State of California – Natural Resources Agency  
DEPARTMENT OF FISH AND WILDLIFE  
Inland Deserts Region  
3602 Inland Empire Boulevard, Suite C-220  
Ontario, CA 91764  
[www.wildlife.ca.gov](http://www.wildlife.ca.gov)

October 10, 2024  
*Sent via email*

**Comments on the Notice of Determination for an Addendum to the 1991 Environmental Impact Report: Water from the Owens Valley to Supply the Second Los Angeles Aqueduct 1970 to 1990, 1990 Onward, Pursuant to a Long-Term Groundwater Management Plan for Replacement of Wells W247 and W379 (Project), SCH# 1989080705, and Notice of Exemption**

## Exhibit 8A

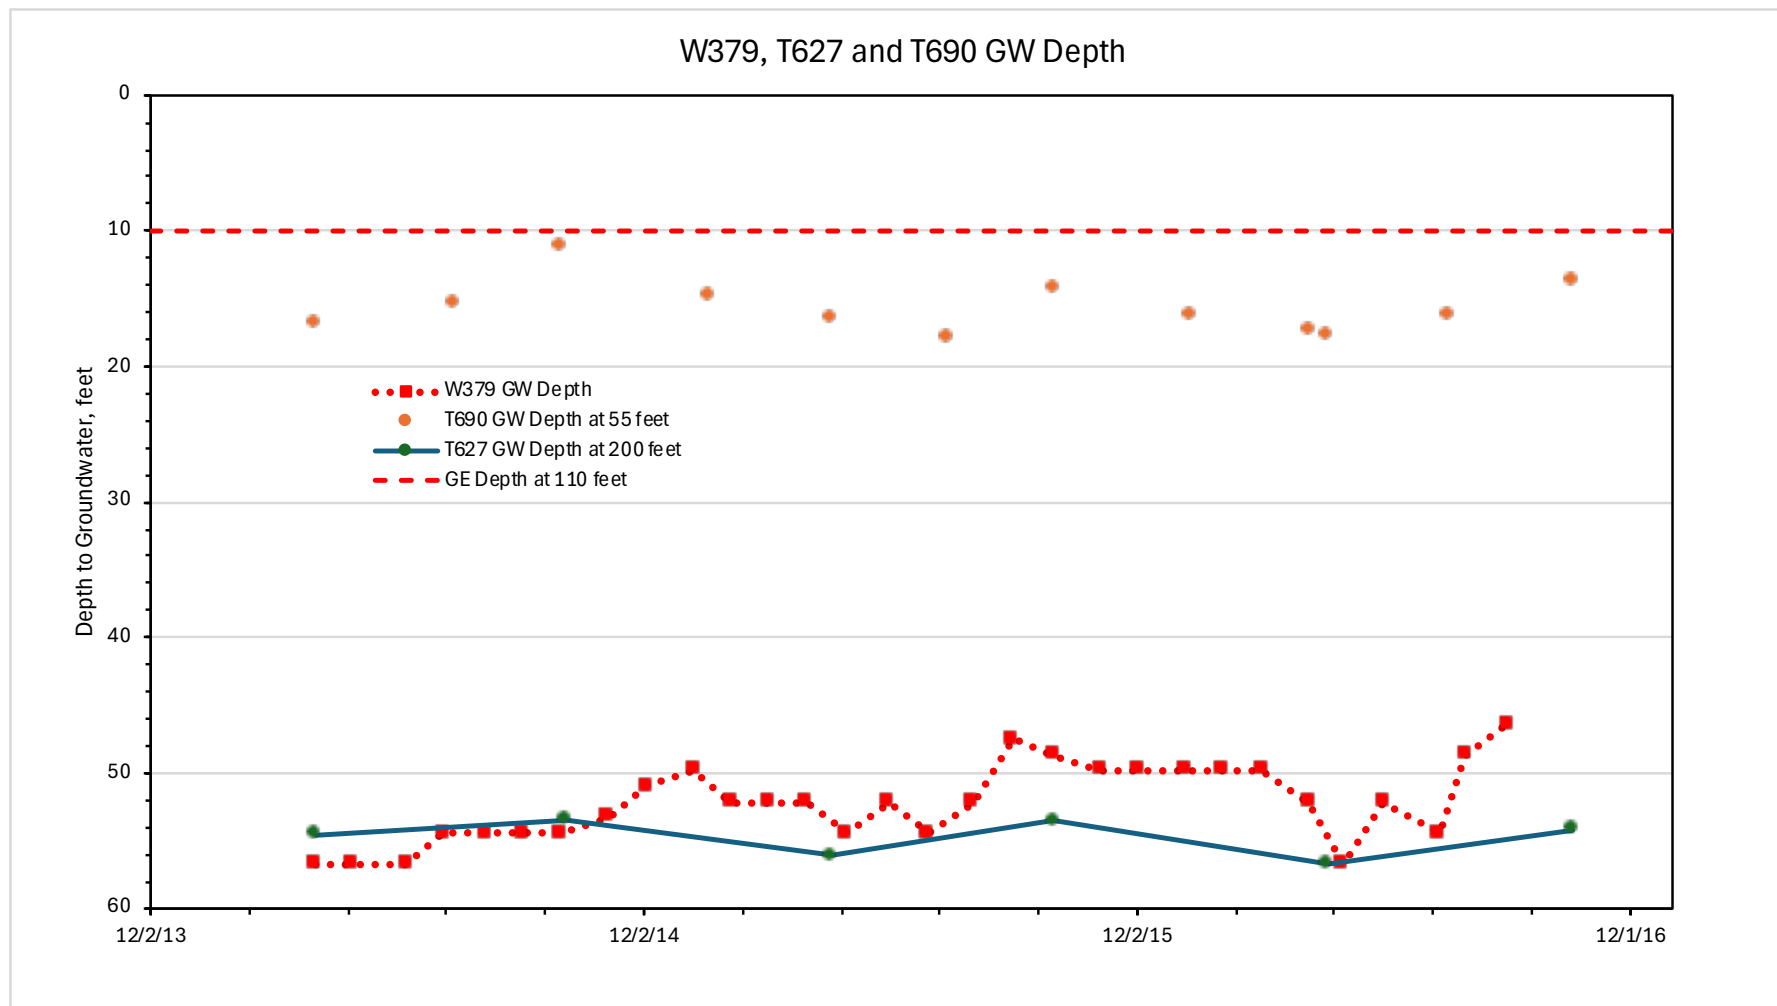
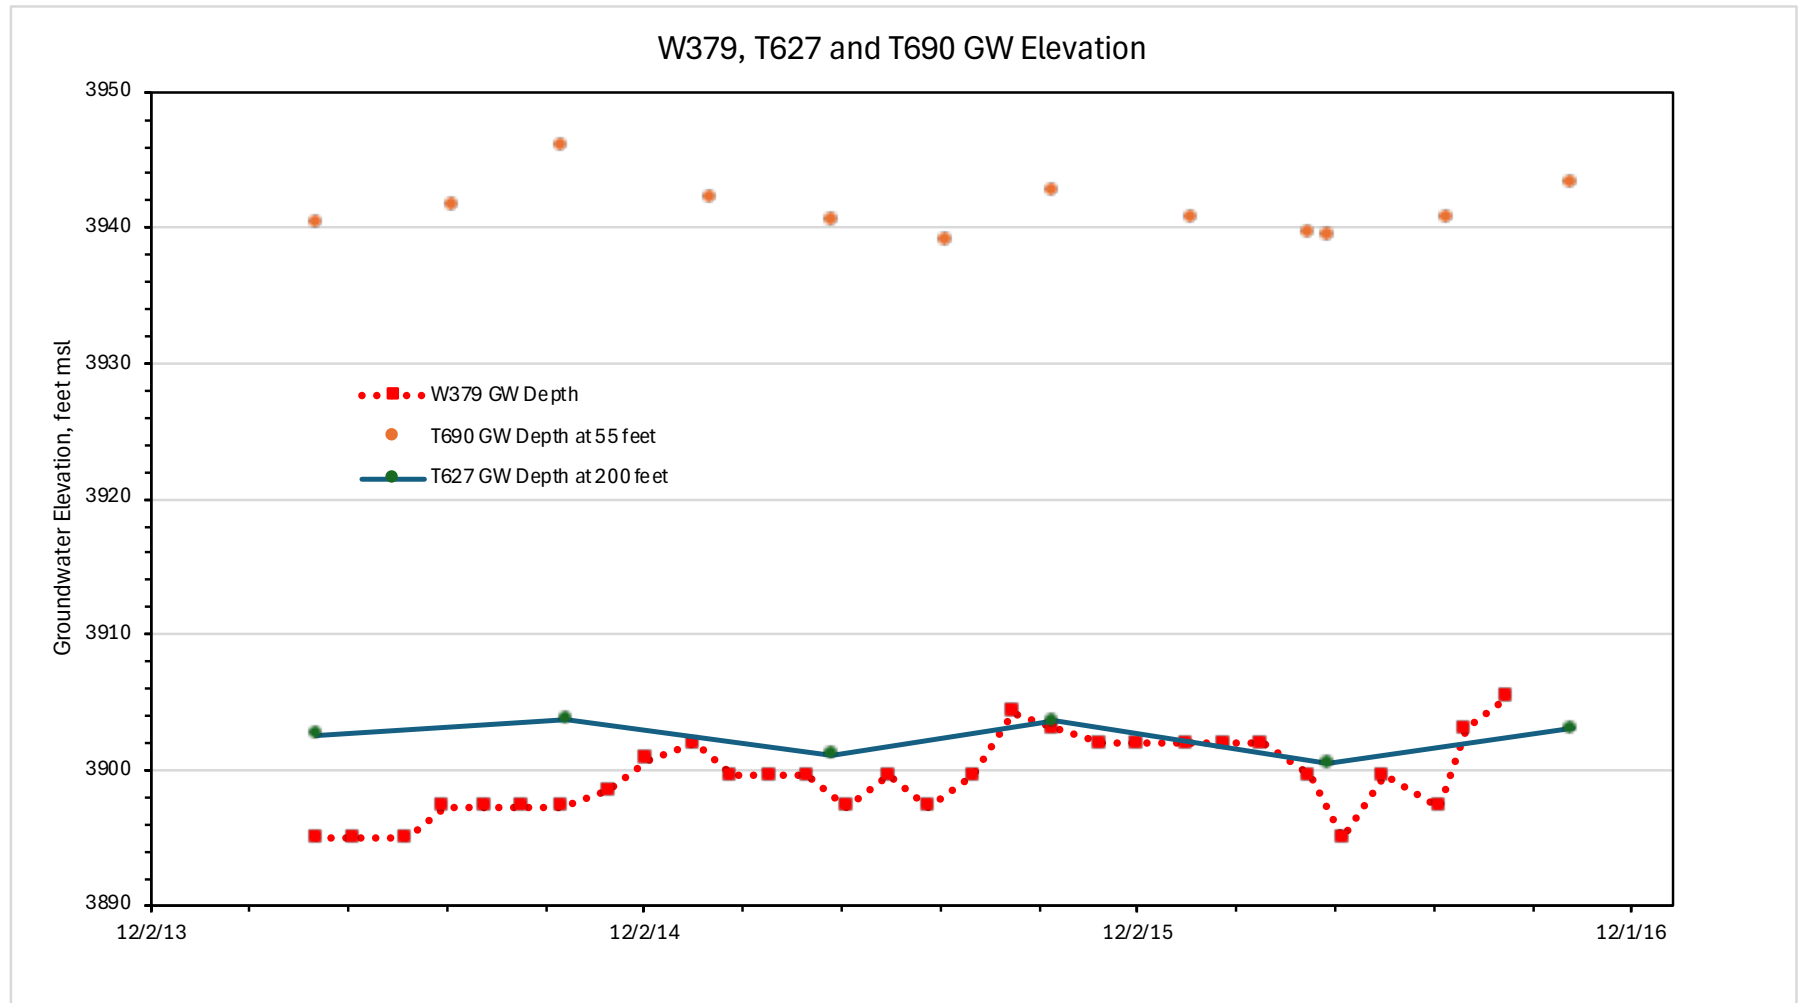
The hydrographs for the wells adjacent to well W379 in the Big Pine Wellfield show a more subdued fluctuation than wells at W247 (Exhibits 8A through 8F). Exhibits 8A and 8B show that around well W379, the depth, and elevation to the shallowest groundwater in well T690 at 55 bgs is significantly higher than at the intermediate and deeper groundwater, wells T627 at 200+ feet bgs and W379 screened from 200 to 400 feet bgs. Note that W379 is now apparently filled in with sand below 200 feet, according to the Pre-Construction Evaluation Report (LADWP, 2024d, page 1). The depths to shallow and deep groundwater to the north of well W379 are different because the depths are closer together. Exhibit 8C is a hydrograph of shallow well T689, which shows fluctuations in groundwater that are generally between 2 and 16 feet bgs, like well T690, Exhibit 8A. The difference comes with the deep well T736. The annual pumping volumes are given in Exhibits 11C and 11D.

CDFW recommends that LADWP conduct the groundwater model simulations for new wells W247R and W379R to estimate changes in shallow and deep groundwater levels using the worst-case three hydrological water years as the Agreement requires. CDFW also recommends resolving data gaps in the hydrogeologic setting at the Laws and Big Pines Wellfields before the worst-case modeling is done. Reporting of the modeling analyses of potential impacts from pumping these deep wells should include documenting when and where the new well drawdowns will change the actual seasonal groundwater elevations and depths below the ground surface, not just the difference in relative drawdowns. Furthermore, to support a conclusion that the new wells will not result in any new significant impacts, the analysis of impacts would need to demonstrate that: 1) pumping these new deeper wells will not result in groundwater levels below 10 feet bgs any longer than the current non-drought condition; 2) the increased drawdown in the deep aquifer systems will not interfere with pumping in adjacent wells; 3) any changes in the magnitude and/or direction of the vertical gradient between the shallow and deep aquifers will not result in additional shallow groundwater storage losses, declines in groundwater levels that harm overlying vegetation and habitats, or changes in groundwater quality in either the shallow or deep aquifers; and 4) the increased deep aquifer pumping will not result in increased loss of groundwater storage or surface water flow in the recharge source areas. Finally, CDFW recommends conducting this analysis of impacts for well W247R to inform whether the increase in deep aquifer pumping results in an impact on groundwater levels to the north in the Chalfant Valley, to the west at Five Bridges near wells W385R and W386R, or northwest at Fish Slough.

Exhibit 8D

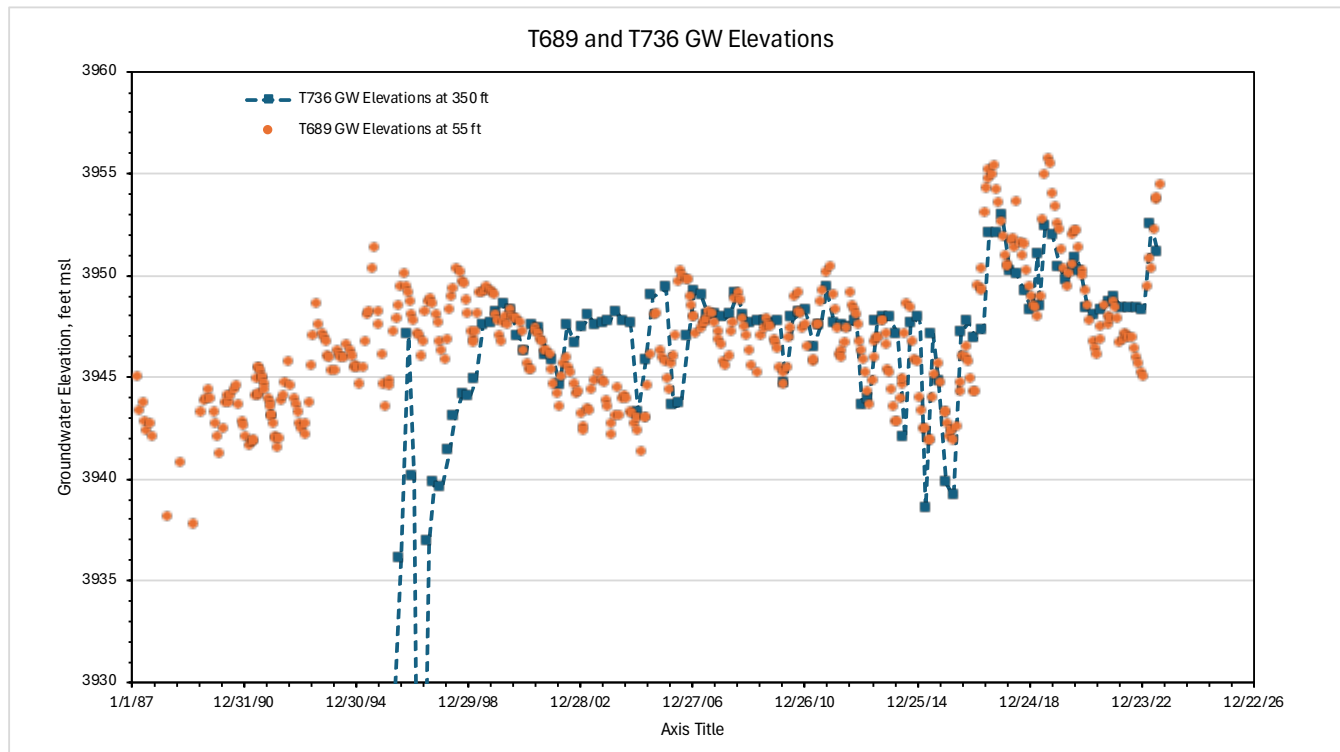
Exhibit 8D is a hydrograph of well T736, at 350 feet bgs, and located approximately 1,300 feet northwest of W379. It shows a large rise in groundwater level from the late 1980s to around the year 2000 when it stabilizes at approximately 10 feet bgs. After 2000, the deep groundwater level in T736 ranges in elevation between approximately 3,943 to 3,953 feet, (Exhibit 8E). This is approximately 40 feet higher than the deep groundwater level at wells W379 and T627, where elevations were at approximately 3,900 feet in 2014-2016 (Exhibit 8B). Exhibit 8E shows the groundwater elevation hydrographs for deep well T736 with the adjacent shallow well T689. The groundwater levels in these adjacent wells appear to fluctuate together after the year 2000, with the deeper elevations in T736 sometimes being higher than the shallow groundwater. This suggests an upward vertical gradient between

the deep and shallow aquifer systems may exist, at least briefly. This upward vertical groundwater gradient contrasts with the apparent downward gradient to the southeast at wells W379 and T690 (Exhibits 8A and 8B). Exhibit 8F shows a plot of groundwater measurements taken in well W378, screened from 200 to 400 feet bgs, with the nearby deep well T736, during the brief period of 2014-2016. The groundwater elevations in well W378 are approximately the same as well W379 at around 3,900 feet elevation. Do these brief W378 elevations represent a period of pumping, as reflected in a similar brief decline in levels in T736 at the same time? Would the groundwater levels in W378 rise to match those in T736 without pumping?
